Docket No. 272 - Development and Management Plan Inspection

Segment 1a Inspection

Date: April 21, 2008

Location: Segment 1a – Scovill Rock Switching Station to Chestnut Junction, Oxbow Junction to

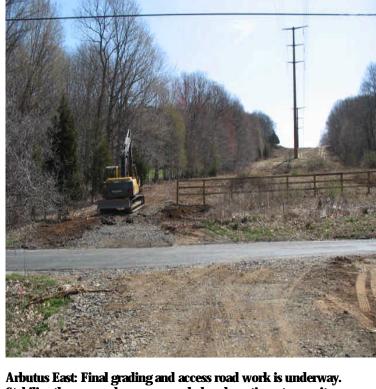
Haddam Quarter Rd: Timber mats were removed from the wetland crossing. Stone and soil were installed for the permanent access road. Consider installing culverts in this area to avoid altering wetland hydrology.

Johnson Ln: A new culvert was installed at the stone wetland crossing to maintain the hydrological connection within the wetland.

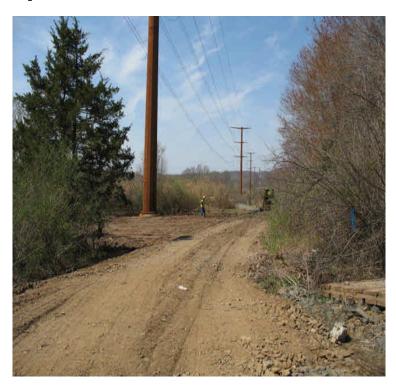
Foot Hills Rd: Timber mats and access road were removed within the ROW and wetlands and the areas were reclaimed. Mulch and seed were applied.

Arbutus St: Restoration and final grading complete west off Arbutus St. Hay/seed have been applied at the last disturbed slope. Add controls along the slope as needed.

Arbutus St to Black Walnut Dr: Final mulch and seeding complete at Arbutus. However, additional mulch and seed needed on exposed slope off Black Walnut.

Stabilize the exposed areas as needed and continue to monitor.
